# THE CORRADINO GROUP, INC.

date: March 27, 2023  
to: Jennifer Hofmeister-Drew, AICP, LCAM, Planner III,  
Town of Palm Beach  
from: Eric Czerniejewski, P.E., ENV SP  
subject: Paramount Palm Beach Traffic Review

## MEMORANDUM

The Corradino Group, Inc (Corradino) has been requested to provide a traffic review of the Traffic Impact Evaluation for the redevelopment of the Paramount Theatre located at 139 North County Road in the Town of Palm Beach, Florida. The following are our traffic review comments based on the 03/09/23 resubmittal.

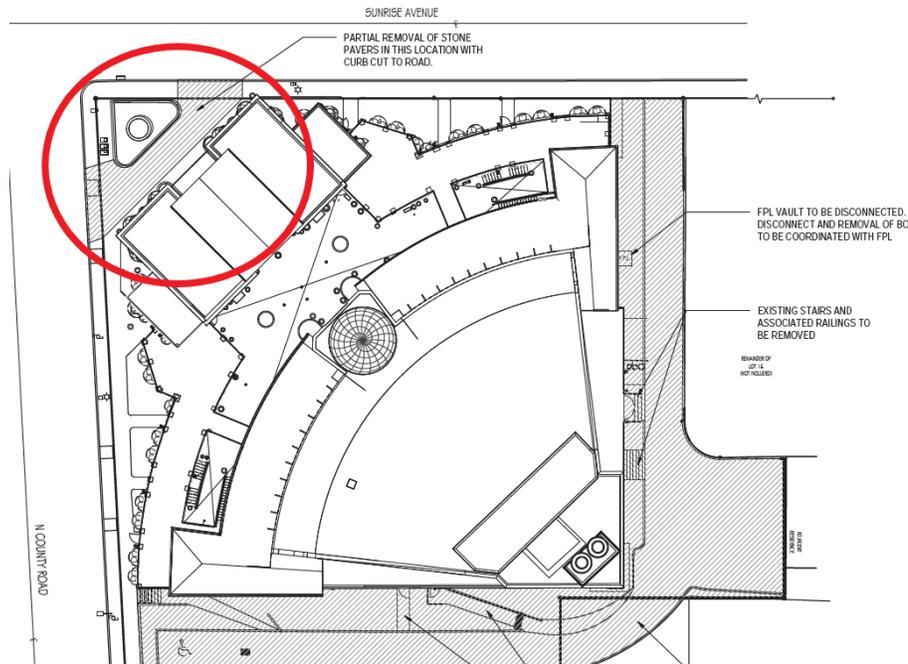
12. Please provide additional narrative that provides the total amount of queuing available from the valet stand to the adjacent road network for both scenarios. Figures 3 and 4 should be updated to denote the total amount of queuing available from the valet stand to the adjacent road network.

**Kimley Horn and Associates, Inc.'s 03/09/23 Response** Additional information is provided in the updated report and Figures 3 and 4 illustrating the queuing available to the adjacent road network. Note that the valet stand for the event space is proposed to be located on North County Road.

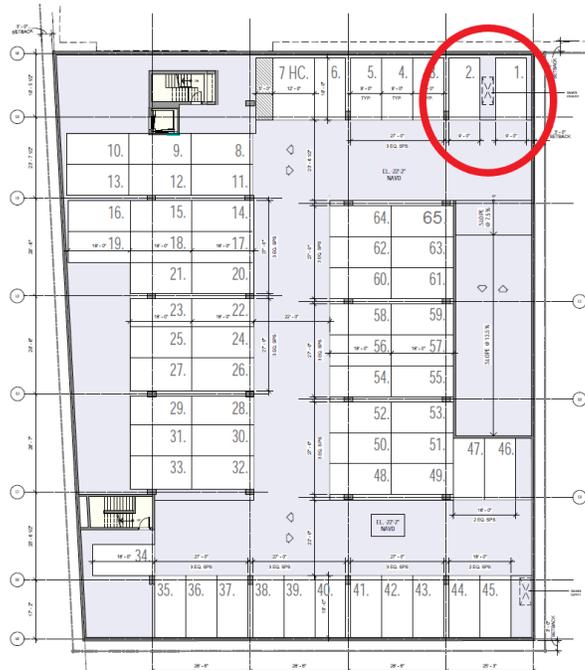
16. Please provide additional narrative for the valet operations that discusses the plan for the potential of valet parking occurring for all uses especially the private club and special event for the banquet hall. Please confirm if there will be staggered times for the special event and private club to manage traffic congestion due to the arrival of attendees for these uses. Please provide details regarding where vehicles will be parked if the proposed number of parking spaces provided on-site are fully occupied. For example, will there be an overflow parking lot with leased spaces available or will on-street parking spaces be utilized.
17. Please update the Kimley Horn and Associates, Inc.'s parking study dated 02/28/23 to include the number of parking spaces being provided per the current site plan as outlined in the parking calculation summary provided on site plan sheet A-21.
